**HOMES NSW  
48 NEW ORLEANS CRESCENT  
MAROUBRA NSW 2035**

**BUILDING CODE OF AUSTRALIA 2022  
UPDATED STAGE C CONCEPT DESIGN REVIEW  
JUNE 2024**

Report prepared for	Homes NSW Locked Bag 4009, Ashfield NSW 1800
Attention:	Patrick Koe
Report prepared by	Metro Building Consultancy Suite 15.14, 60 Station Street Parramatta 2150
	Consultant: Sean Moore
Report reference	23192R04
Job number	23192
Date	21 <sup>st</sup> June 2024

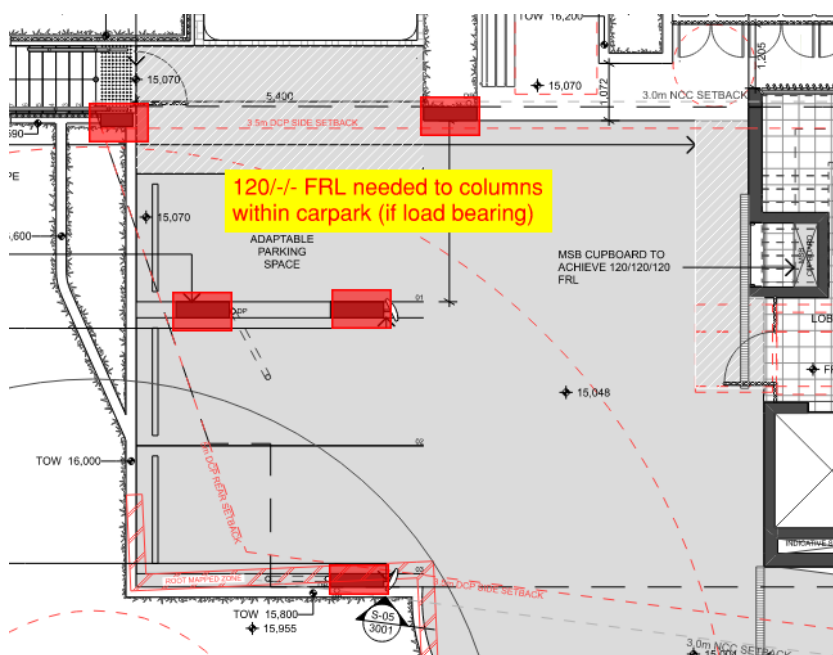
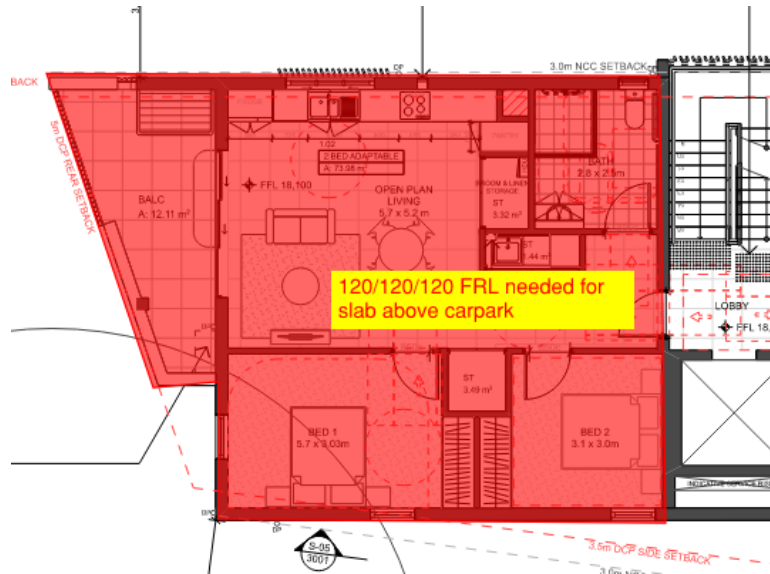
The assessment of the floor area of the fire compartment includes the under-croft carpark as contribute to the fire load (contains cars, exposed insulation, timber battens etc).

As such the floor area of the building is more than 500m<sup>2</sup> and requires a fire hydrant system. A fire hydrant booster has been proposed on the drawings.

The under-croft carpark on the ground floor is more than 10% of the floor area as such the external elements supporting the carpark requires an FRL or 2 hours rather than 90 minutes needed for the residential units.

Under BCA Clause C3D10 the floor between the adjoining parts must have an FRL not less than the storey below. As the storey below level 1 is carpark then the residential floor slab is required to achieve the FRL of the storey below which is 120/120/120.

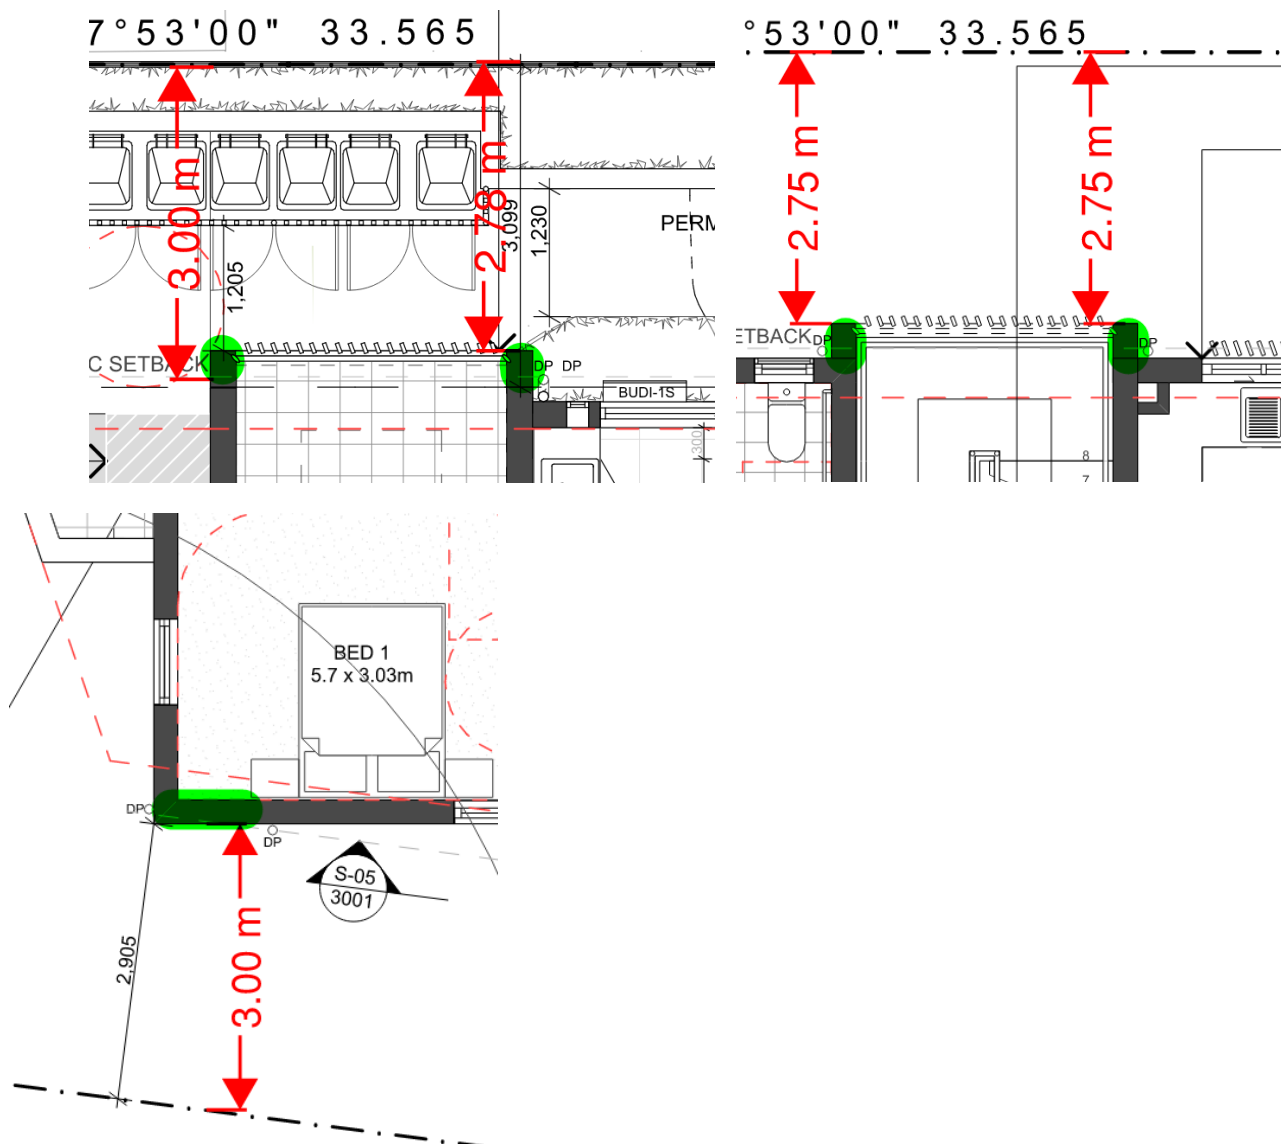
Parts of the northern and southern wall that are within 3m from the boundary triggers the wall to have a higher FRL than the other parts of the wall that are more 3m away from the boundary.

The off-form concrete doesn't provide support to the external wall as such is considered non-load bearing but will still require an FRL as its within 3m from the boundary.

External Louvres can be considered an attachment to the wall and only need to be non-combustible and don't need to be fire rated.

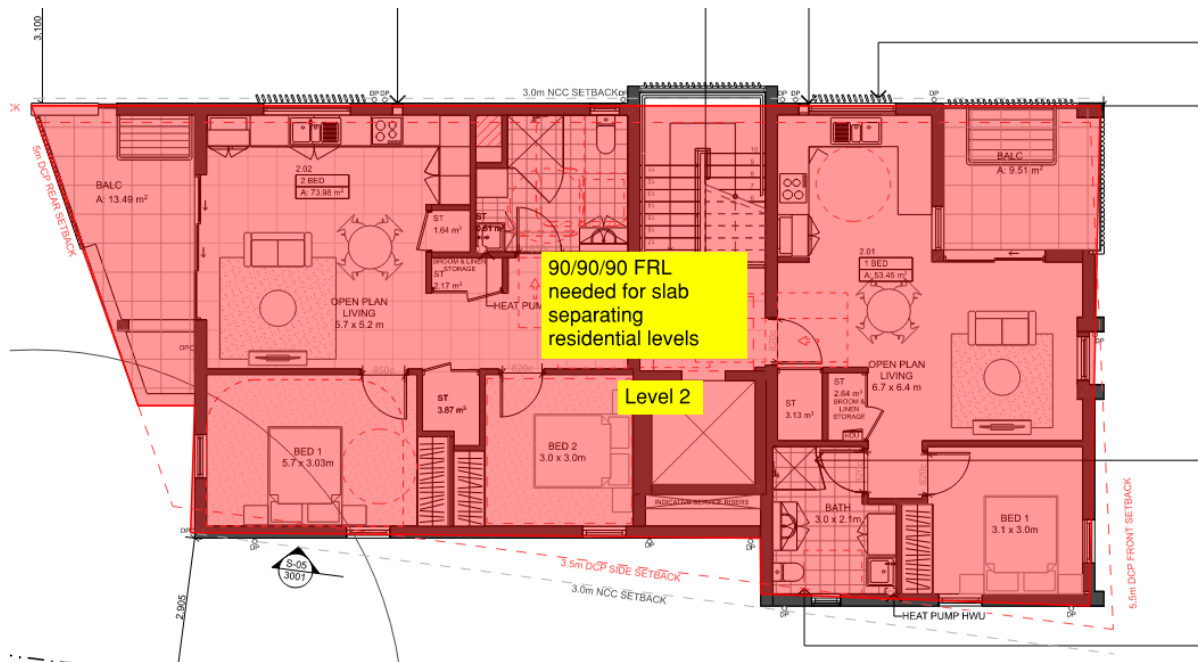
During design development provide a detail of how the fire rated floor slab separating storeys connects to the façade and creates the fire separation required between floors.

The slab separating the carpark and apartment requires and FRL of 120/120/120.

The slabs separating the apartment require an FRL of 90/90/90.

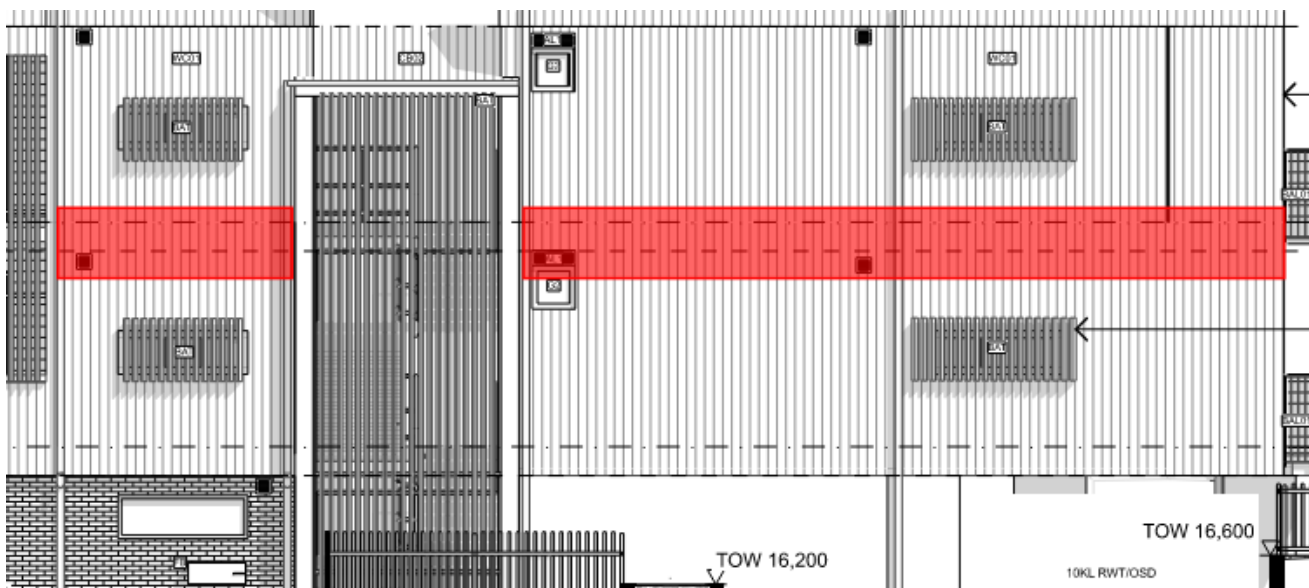
Spandrel protection is needed throughout regardless of window location due to the external wall not having an FRL of 60/60/60. Please confirm FRLs of external wall.

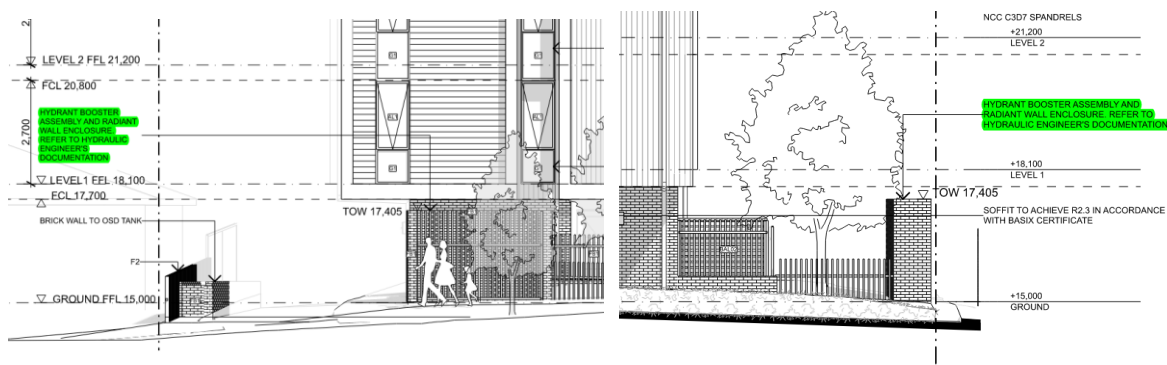
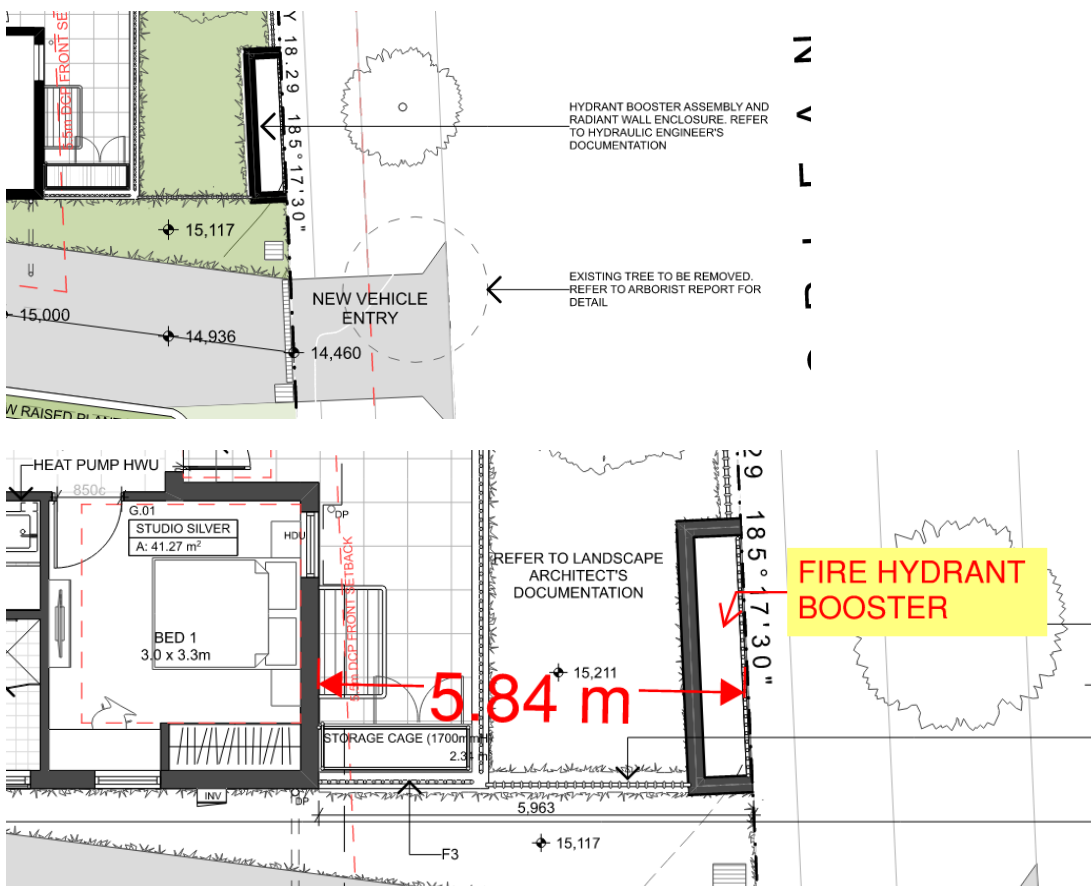
All points of the floor to be within 40m of an internal hydrant.

Internal fire hydrants shall be located within 4m from the stairs.

Please provide details to confirm compliance has been achieved.

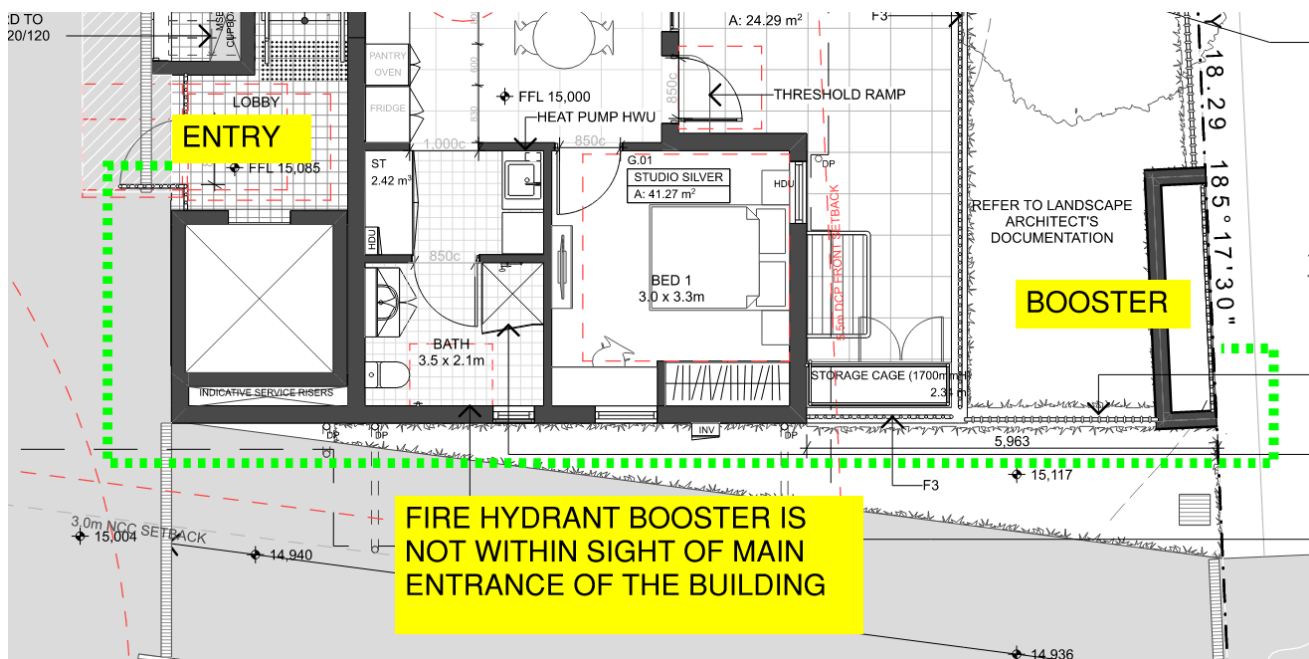
The fire hydrant booster location is not within sight of the main entrance of the building. As such will need to be addressed under a fire engineered performance solution.
